Report: TAB Report
Function: Test, Adjust, & Balance
Date: 06/07/2024

PROJECT

06-03-24 WAWA #8187 TANNERSVILLE, PA

image
06/05/2024

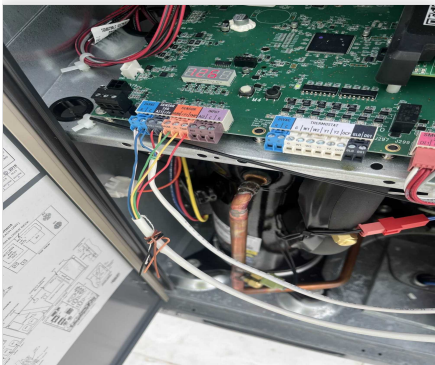
Issue Name : EF Securement
Description : The EFs are not secured to the curbs. Recommend securing to the curbs with proper fasteners. (Applies to all Exhaust fans)
Created By : National TAB **Assigned To :** National TAB - Tyler Youells
Status : Open
Priority : Medium **Asset Tag :**
Originated Date : 06/05/2024 - Tyler Youells - National TAB

IMG_6803
06/05/2024

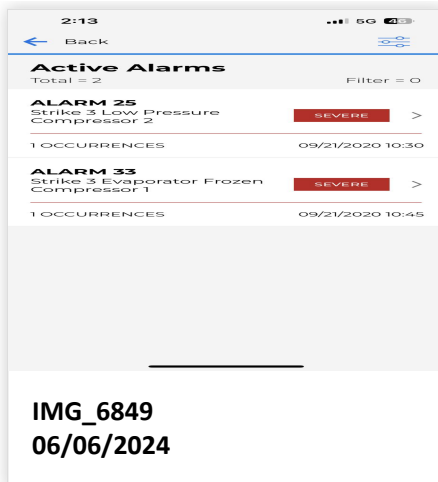
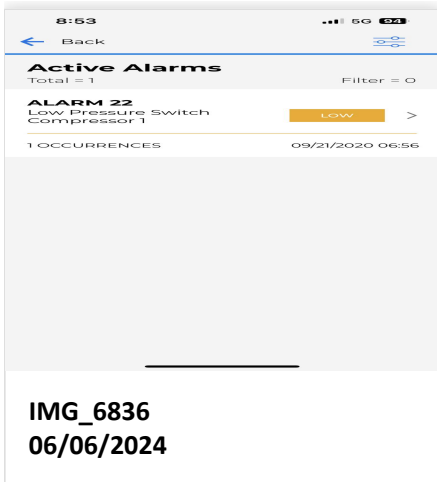
Issue Name : RTU Sensor Wiring
Description : RTU sensor wiring is not run per manufacturers specifications. Typical thermostat wiring was used. Spec calls for separate sets of two wire shielded for the humidity sensor and temperature sensor. Recommend replacing wire to ensure sensor will read correctly preventing any space comfort issues.

IMG_6802
06/05/2024

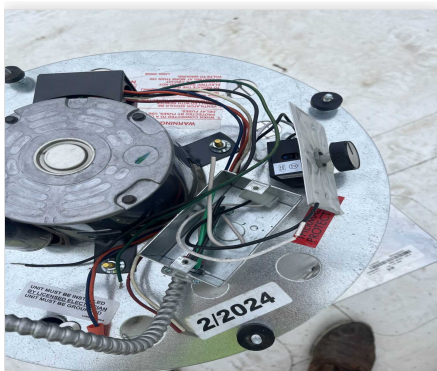
Issue Name : RTU-3 Power exhaust Kit
Description : The factory shipping cover is installed on RTU-3 power exhaust. Cover needs to be removed and backdraft louvers installed for proper function and operation of the power exhaust. Recommend contacting Lennox if Backdraft louvers cannot be located. Not TAB Critical
Created By : National TAB **Assigned To :** National TAB - Tyler Youells
Status : Open
Priority : High **Asset Tag :**
Originated Date : 06/05/2024 - Tyler Youells - National TAB

IMG_6806
06/05/2024

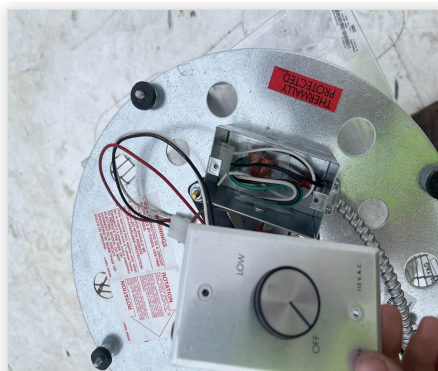
Issue Name : All EF Speed controls
Description : EFS are not wired to power and do not have speed controllers installed. Speed controllers need to be installed ASAP so balance can be completed.
Created By : National TAB **Assigned To :** National TAB - Tyler Youells
Status : Closed
Priority : Urgent **Asset Tag :**
Originated Date : 06/05/2024 - Tyler Youells - National TAB

- **06/05/2024 National TAB - Tyler Youells**
 - All speed controllers are installed and fans powered.

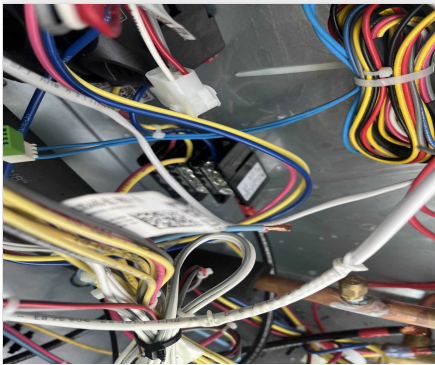
Issue Name : RTU-1/2 Phasing issue
Description : RTU-1/2 both have a phase error alarm preventing the units from running. Electrician to swap phases and resolve.
Created By : National TAB **Assigned To :** National TAB - Tyler Youells
Status : Closed
Priority : Urgent **Asset Tag :**
Originated Date : 06/05/2024 - Tyler Youells - National TAB

- **06/05/2024 National TAB - Tyler Youells**
 - Electrician has resolved phasing issues and both units are now running.
